General Contractor for Sterling Hall School – Campus Expansion Project

ADDENDUM #6 – JULY 31, 2026

**RESPONSES TO CLARIFICATION QUESTIONS RECEIVED (PARTIAL) +
ARCHITECTURAL ADDENDUM #4 + UPDATED BID FORM SUPPLEMENT +
DROPBOX (ALL FILES/UNLOCKED)**

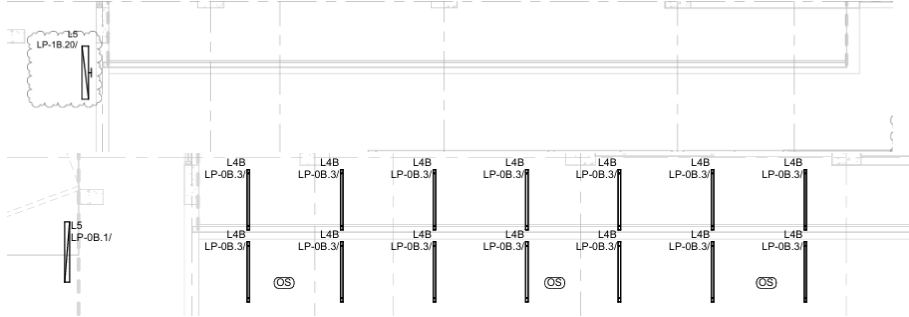
35. Could you please clarify where the following Specifications sections are to be applied, since Drawings and specs don't identify the locations:

- **Section 07 13 00** – Sheet waterproofing @ open cut foundations
- **Section 07 14 00** – Fluid applied waterproofing ?
- **Section 07 15 57** – Concrete Tank waterproof?
- **Section 07 16 00** – Cementitious waterproofing @ elevator pit/ sump pit
- **Section 07 17 00** – Blind-side waterproofing ?

Please refer to Addendum documents for further clarifications on the above, noting Geotechnical

Report/reference to water levels on site.
